## 01-22-05 - Update Programming Engine/Motor Control Module - J623- for Various Concerns

Release date: 1/17/2023

Revision Table			
Instance Number	Published Date	Version Number	Reason For Update
2068071/4	1/17/2023	01-22-05	To cover 2022 Taos models produced in 2021.
2068071/3	10/26/2022	01-22-05	To add additional fault criteria
2068071/2	10/10/2022	01-22-05	Correct to labor operation number in warranty table.
2068071/1	9/22/2022	01-22-05	Original publication.

Figure 1.

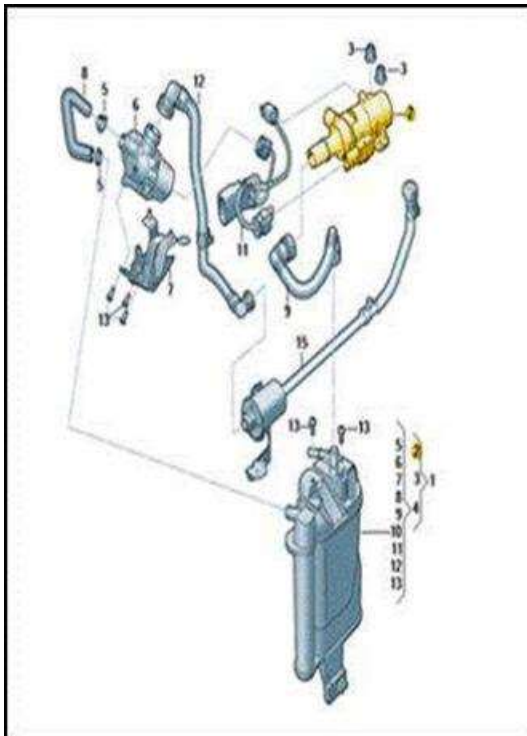
In addition to the software improvement, there is also an improvement to the FTIV (fuel tank isolation valve/tank switch-off valve -**N288**-) (Figure 1.), which is necessary in preventing erroneous occurrences of the P2421 fault code.

The FTIV / Tank switch-off valve -**N288**- currently installed on the vehicle must be inspected, to verify whether an improved part has already been installed. The FTIV / Tank switch-off valve -N288- is mounted to the EVAP canister assembly, as shown below.

Remove the EVAP canister assembly and inspect the face of the FTIV / Tank switch-off valve -**N288**-. If the part is already updated, it will have a white paint marking or "02S" printed after the part number, as shown in Figure 2 and Figure 3. **Alternatively, part number 5Q0 201 549 C is also up to date.**
